Access Compliance Report

(Curb Ramps)

Intersection ID: 10014519	Main Street: UNIVERSITY_POINTE_BV	Cross Street: N/A	Location: SE
ADA ID: 9639828C4124	Ramp Type: Perp	Initial Pass/Fail: Fail	Overall Compliance: No
Severity Score: 21.25			
Codes/Mitigation Info/Possible Solution		Field Measurements/Component Compliance

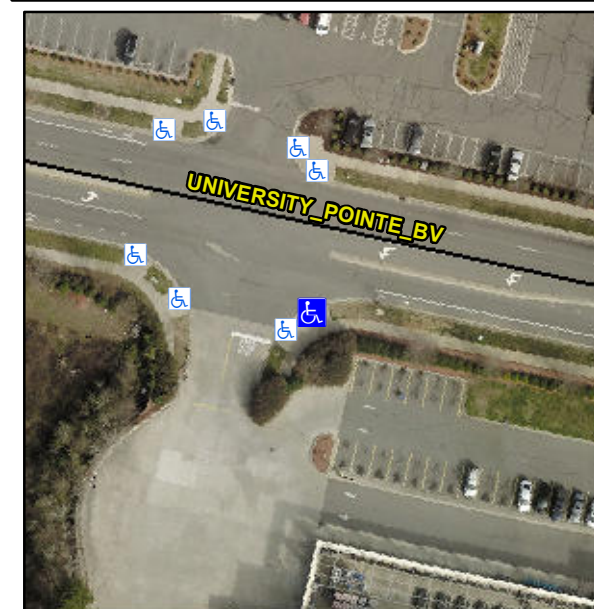
Not Found, R304.5.1, R304.2.2

Compliance	Description	Data	Compliance	Description	Data
N/A	Ramp Length (in)	96.0	No	Ramp Slope (%)	9.0
No	Ramp Width (in)	47.0	Yes	Ramp XSlope (%)	0.9
N/A	Flare Type LT	N/A	N/A	Flare Type RT	N/A
N/A	Flare Slope LT (%)	N/A	N/A	Flare Slope RT (%)	N/A
N/A	Flare Traversable LT?	N/A	N/A	Flare Traversable RT?	N/A
N/A	Landing Length (in)	N/A	N/A	DWS Provided?	N/A
N/A	Landing Width (in)	N/A	N/A	DWS Contrast?	N/A
N/A	Landing Slope (%)	N/A	N/A	DWS Length (in)	N/A
N/A	Landing X Slope (%)	N/A	N/A	DWS Full Width?	N/A
N/A	Landing Curb? (Y/N)	N/A	N/A	DWS Offset (in)	N/A
N/A	Shared Landing?	N/A			
N/A	Gutter Ponding?	N/A	N/A	Gutter Slope (%)	N/A
N/A	Gutter Lip Ht (in)	N/A	N/A	Gutter X Slope (%)	N/A
N/A	Painted X Walk1?	No	N/A	Painted X Walk2?	N/A
	X Walk 1 Direction	To N		X Walk 2 Direction	N/A
N/A	X Walk 1 Width (in)	N/A	N/A	X Walk 2 Width (in)	N/A
	X Walk 1 Slope (%)	1.6		X Walk 2 Slope (%)	N/A
	X Walk 1 X Slope (%)	0.6		X Walk 2 X Slope (%)	N/A

Remove & Replace Entire Ramp.
